STAFF RECOMMENDATION 1909 Shelby Avenue October 16, 2019

Application: New Construction—Addition; Setback determination
District: Lockeland Springs-East End Neighborhood Conservation Zoning Overlay
Council District: 06
Base Zoning: R6
Map and Parcel Number: 08314034800
Applicant: Cheyenne Smith
Project Lead: Melissa Baldock, melissa.baldock@nashville.gov

Description of Project: The applicant proposes to construct rear addition. The addition will be no wider than the historic house and requires a side setback determination. Base zoning requires a five foot (5') side setback, but the applicant is proposing a left side setback of two feet, seven inches (2'7").

Figure 1. 1909 Shelby Avenue.

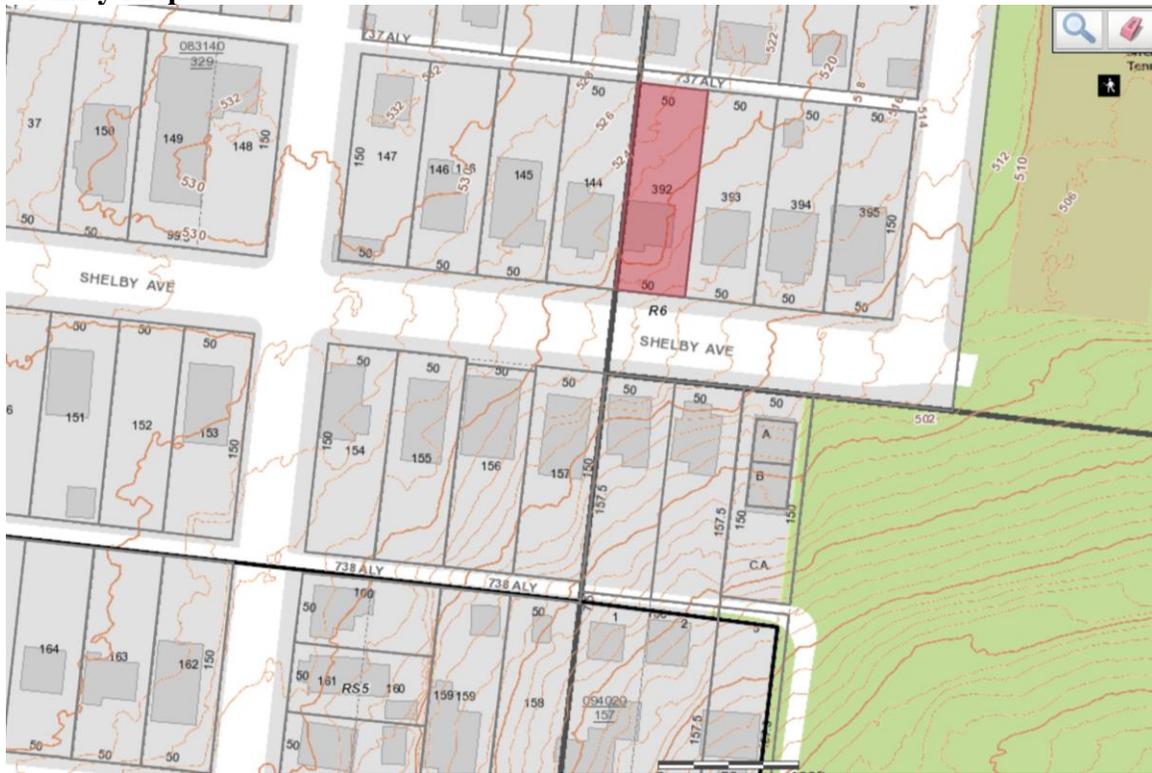
Background: 1909 Shelby Avenue is a c. 1929 frame cottage that contributes to the historic character of the Lockeland Springs-East End Neighborhood Conservation Zoning Overlay (Figure 1).

Figure 2. Approximate location of the proposed new window opening.

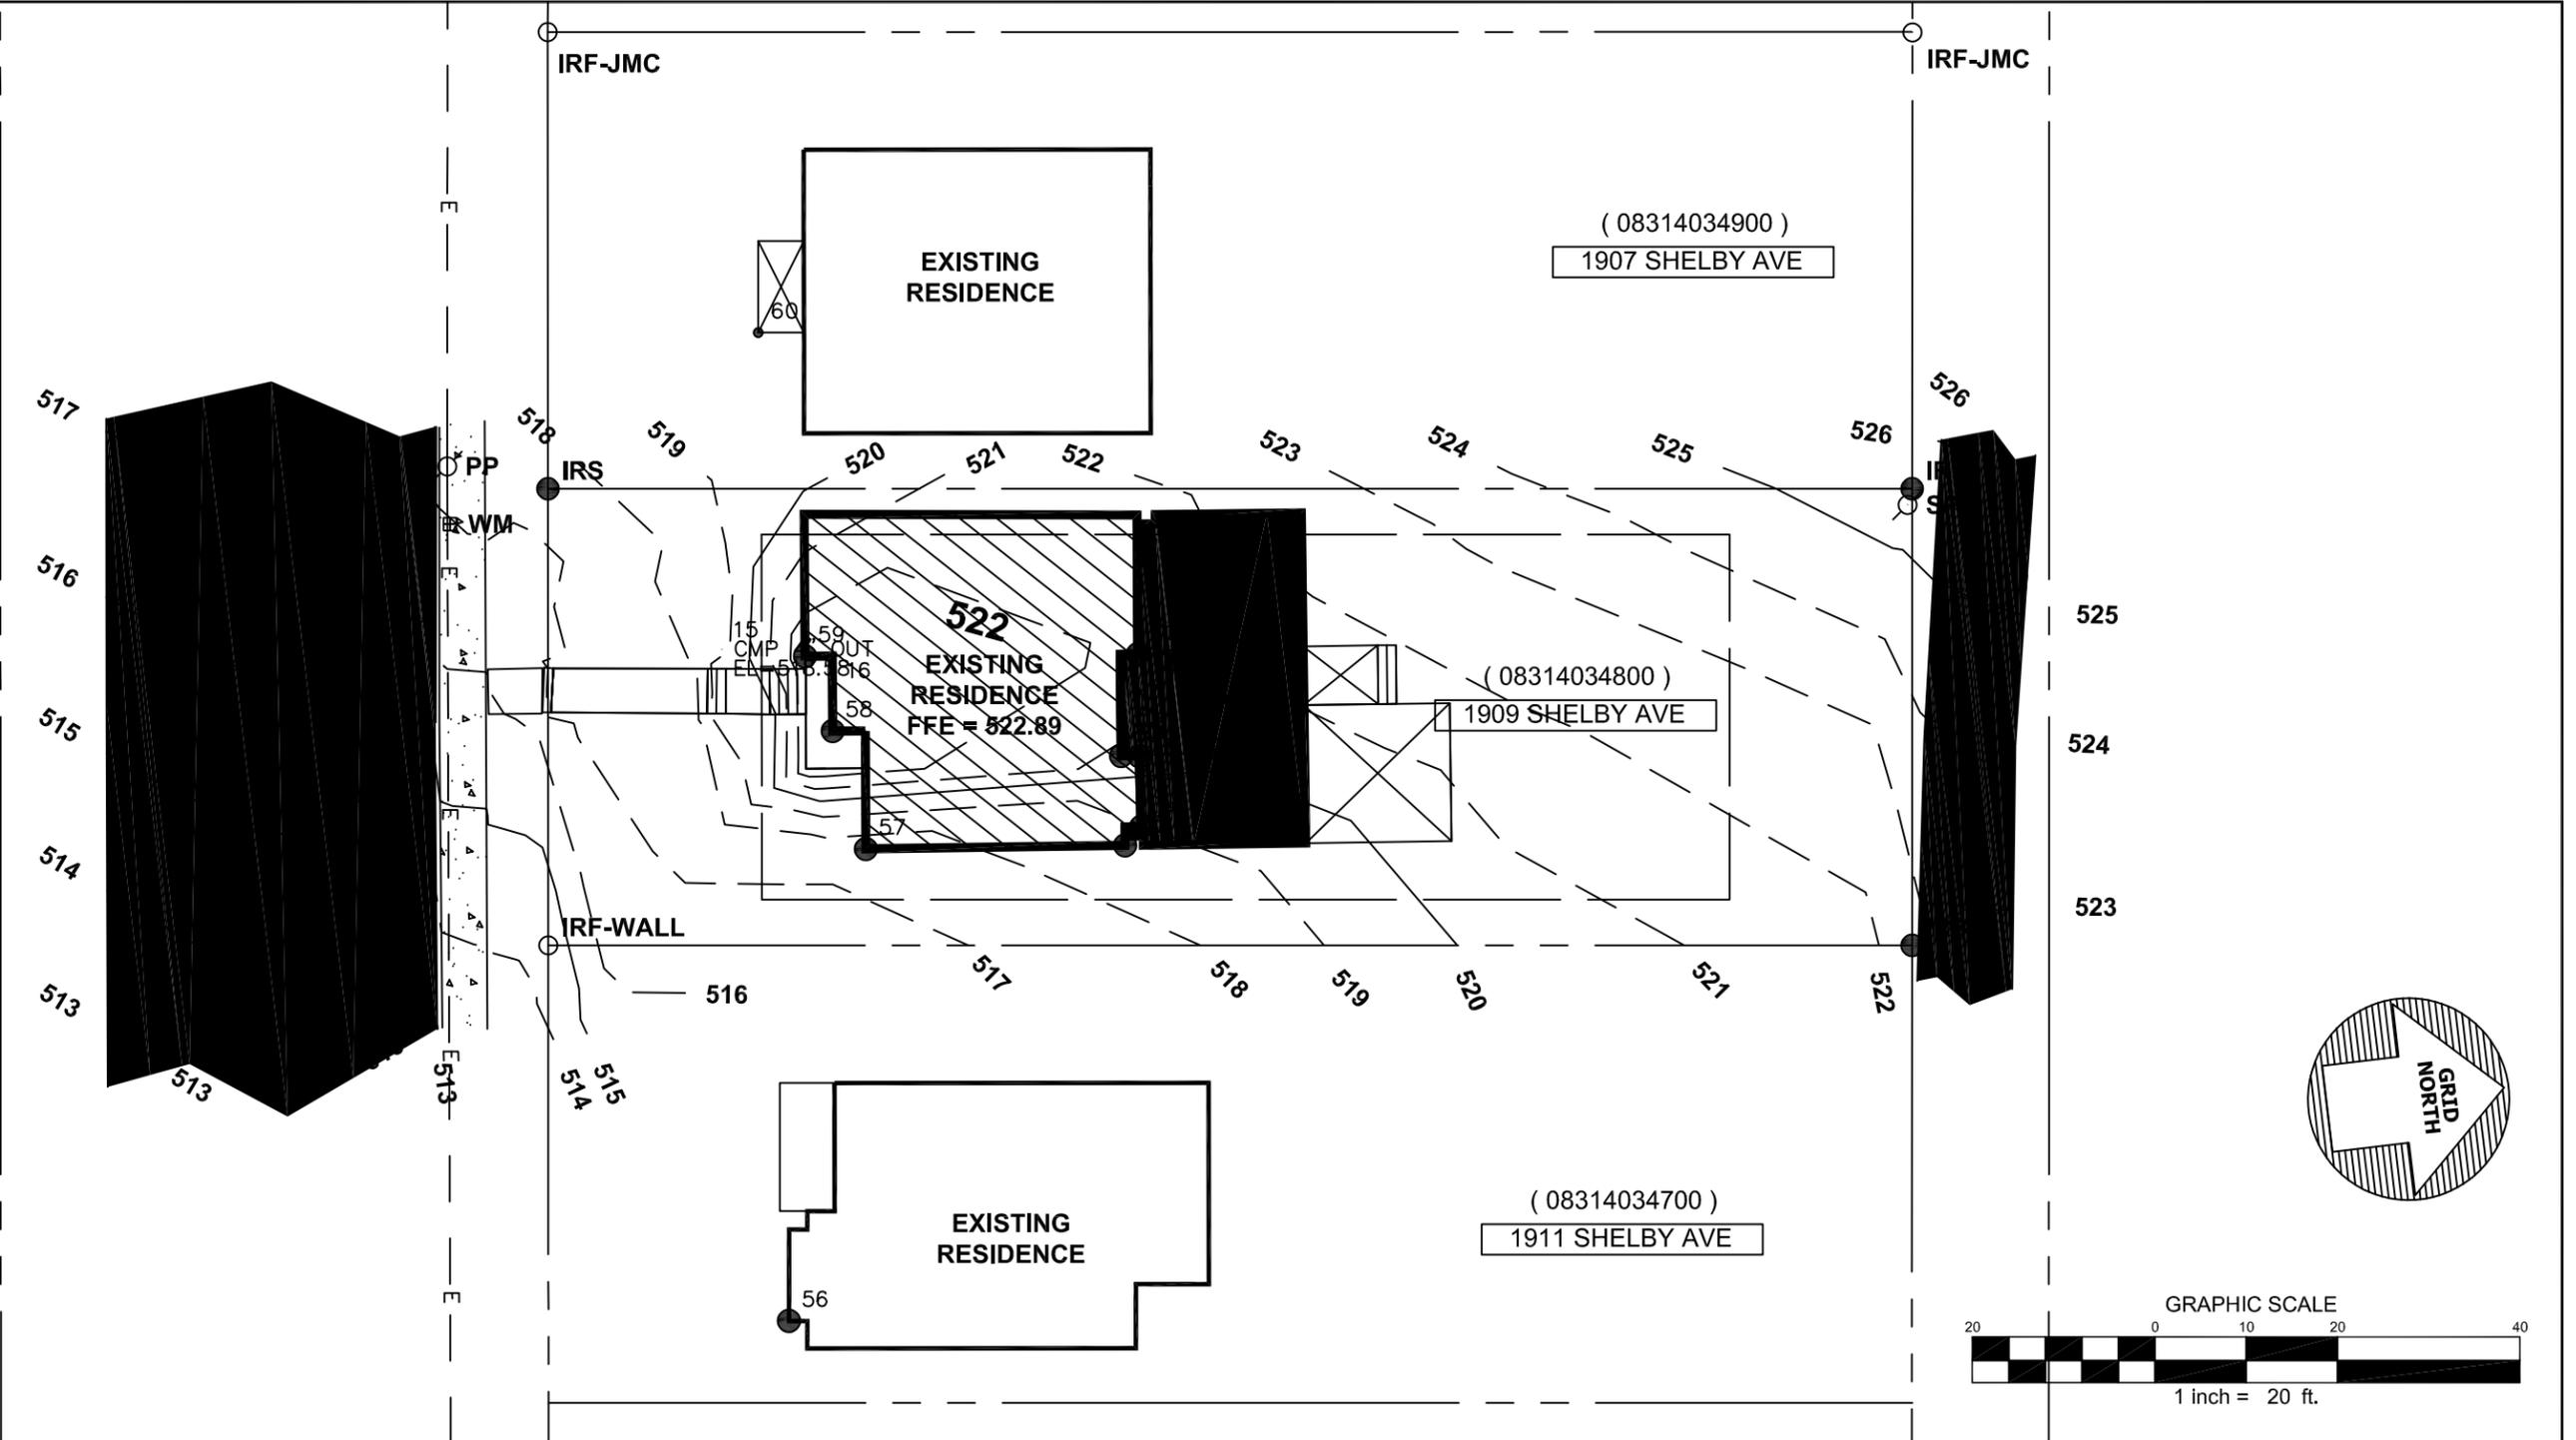
Partial Demolition: The applicant proposes to add a window to the middle of the gable field on the right side, which is considered to be partial demolition. The window will be added at the center of the gable field, which is where windows were often located (Figure 2). It will not interfere with the existing historic chimney, which will remain. Staff finds that this one window change is appropriate because the window is located where windows were often historically located in side gables and because the window allows this part of the interior to be used as a bedroom.

Staff finds that the partial demolition for the window in the gable field on the right side is appropriate. Staff finds that the proposed partial demolition meets Section III.B.2. of the design guidelines.

EXTERIOR
ELEVATIONS

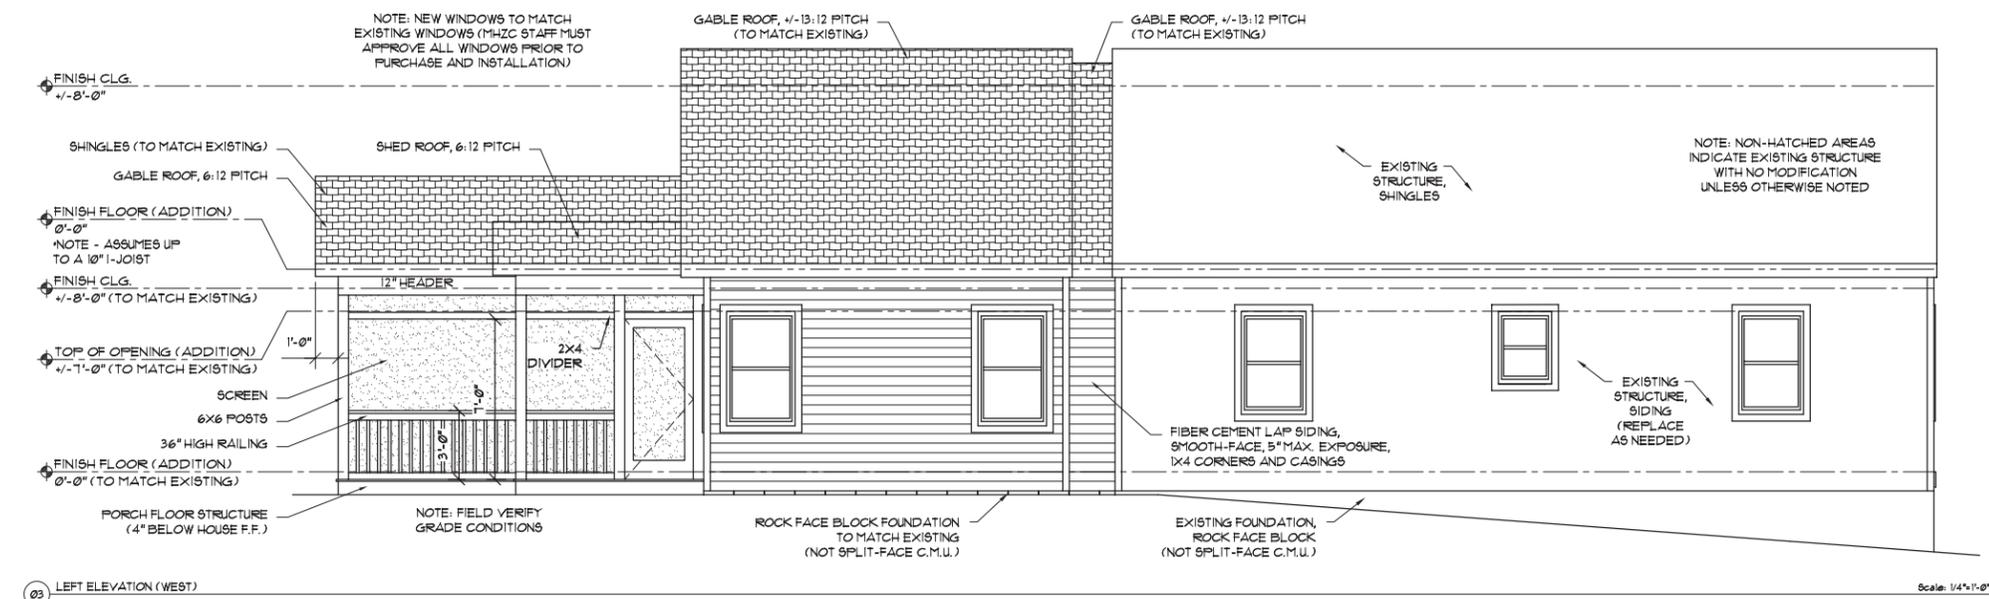
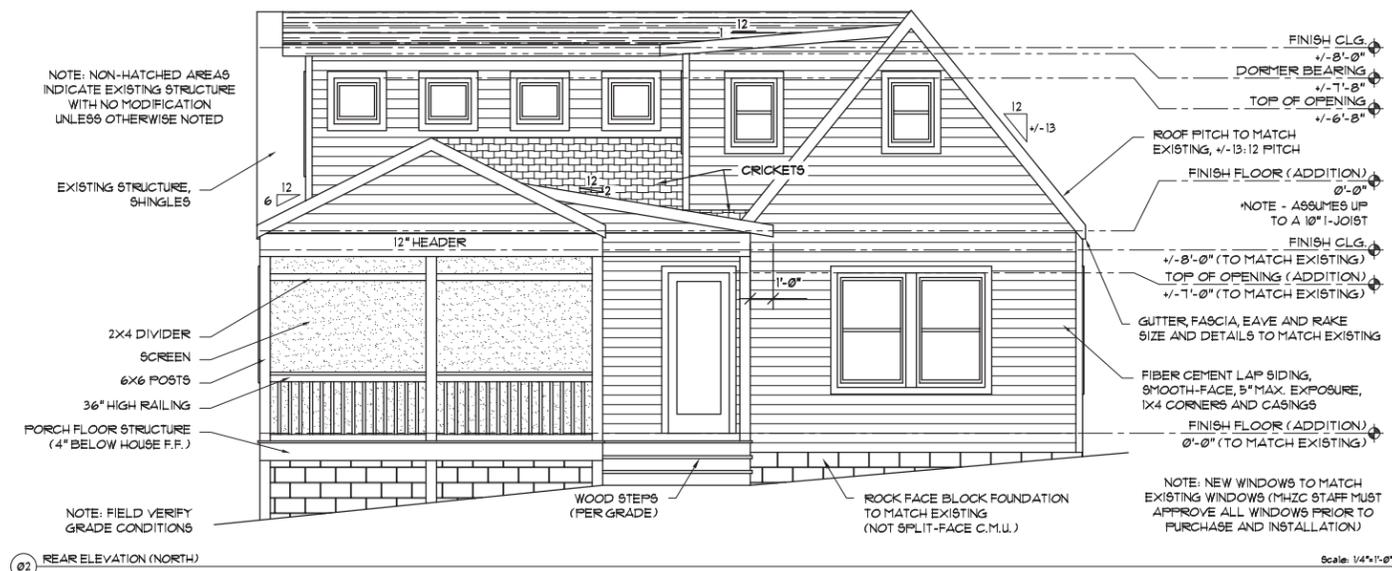
Existing chimney not shown on the drawings but is to remain. Demolition of chimney not proposed
